PID No. 77366

S.R. 823 OVER WEBSTER STREET (S.R. 140)

PRELIMINARY DESIGN REPORT SUBMITTAL

**SUBJECT: Preliminary Design Report Submittal
SR 823 over Webster Street (SR 140)
SCI-823-0.00 Portsmouth Bypass
PID#77366**

DESIGN AGENCY: **TranSystems**
 DATE: 6/11/07
 REVISION: MSL
 STRUCTURE FILE NUMBER: 730631B
 DRAWN: CAS
 CHECKED: MTN
 DESIGNED: PJP
 MSL
 SCIOTO COUNTY STA. 61+61.15 STA. 62+71.30
 BRIDGE NO. SCI-823-017 R
 S.R. 823 OVER WEBSTER STREET (SR 140)
 SCI-823-0.00
 PID 77366
 2/7
 814
 847

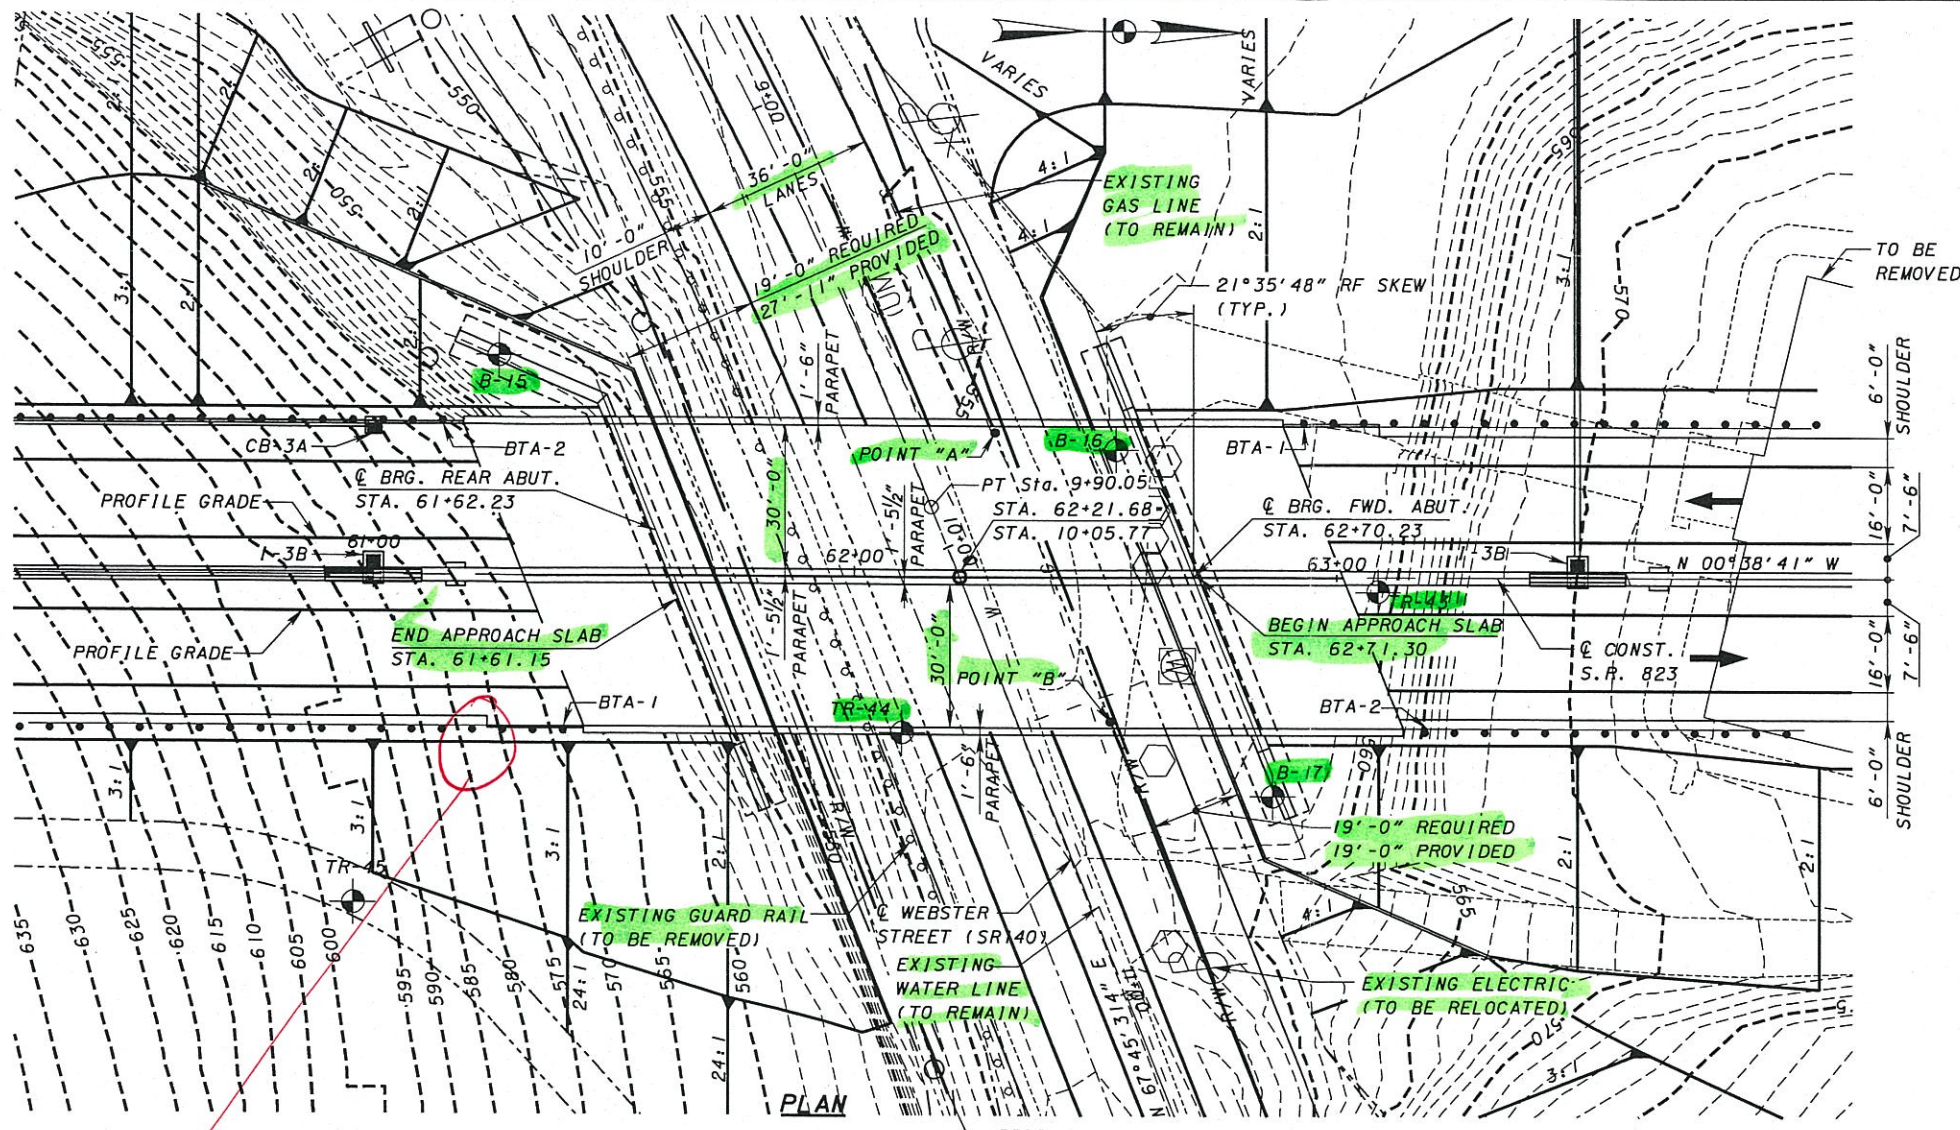
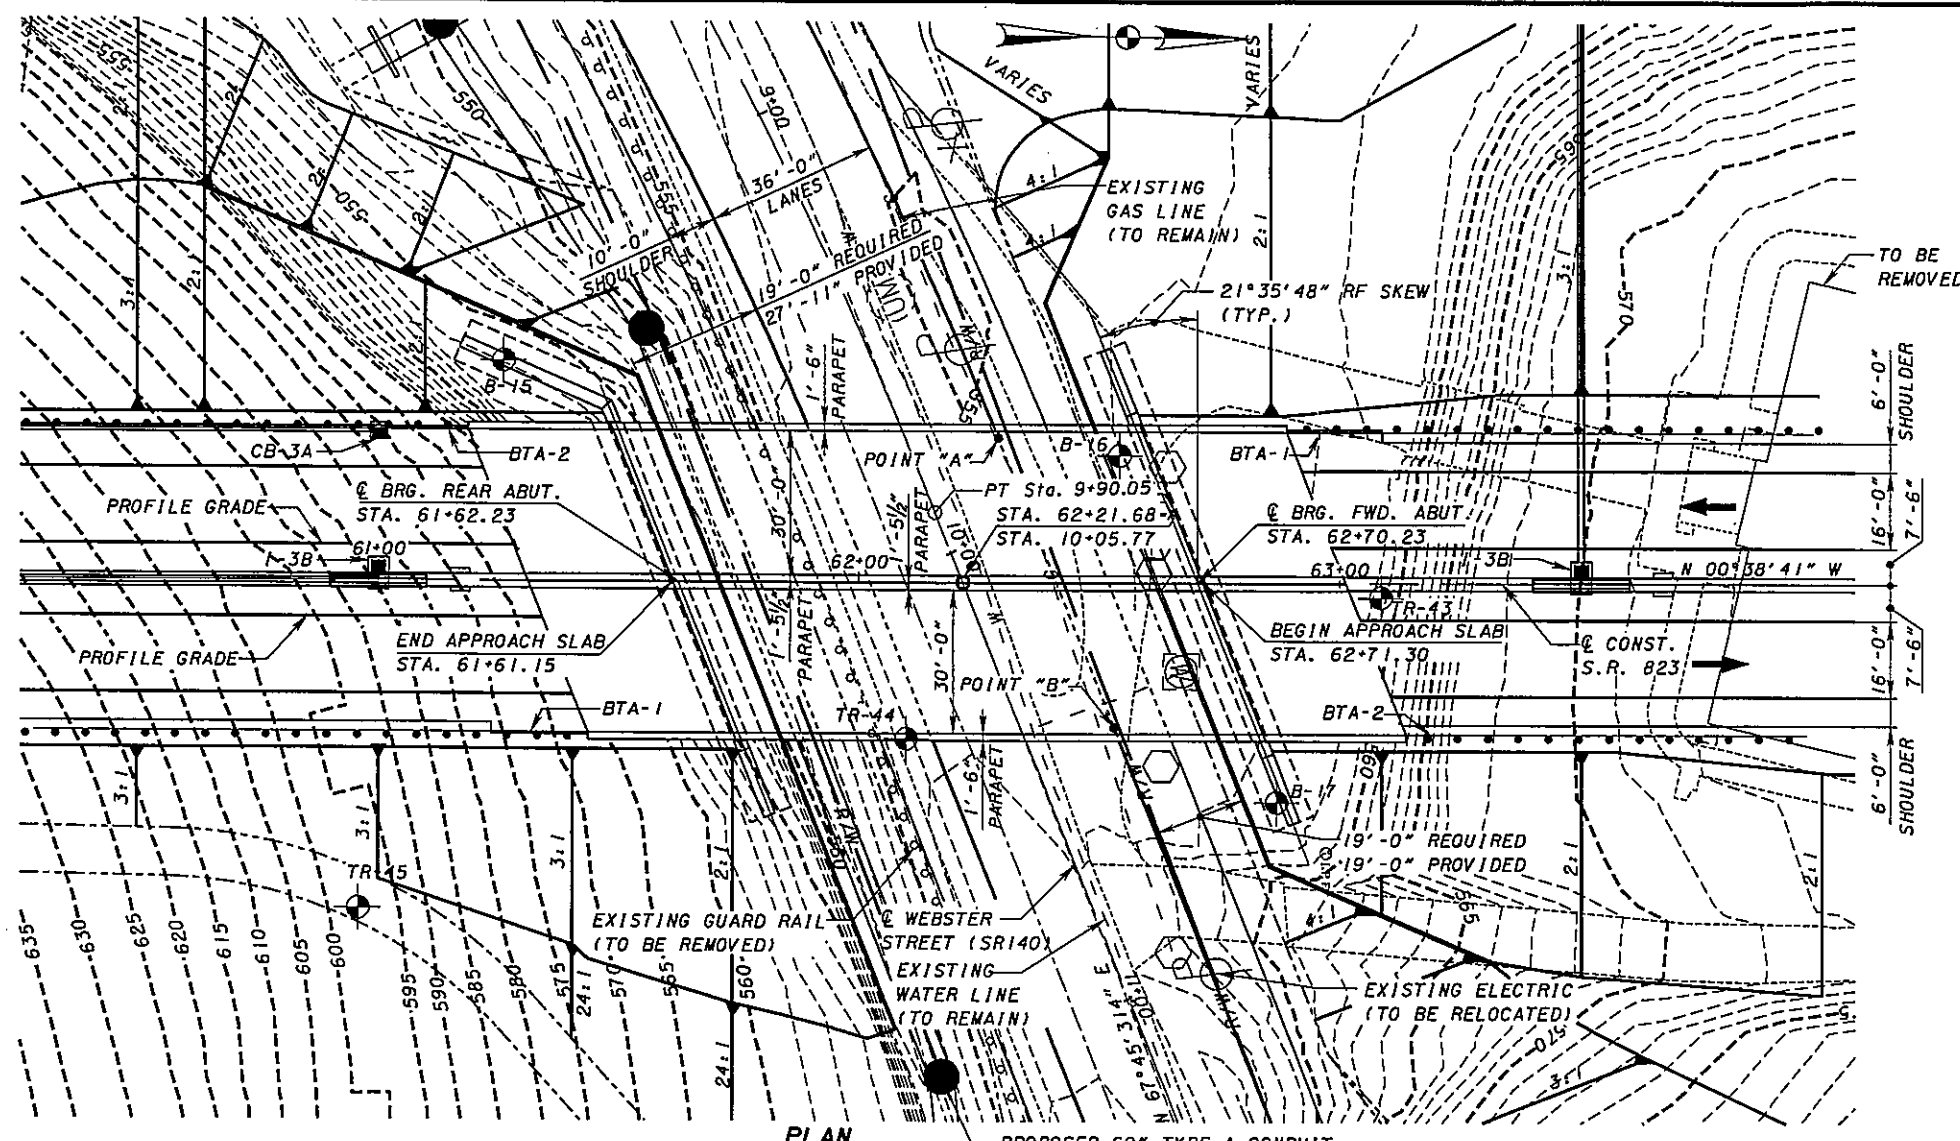
Please verify the bridge limits stationing shown in the title block of site plan.

The limits have been revised in the attached plans.
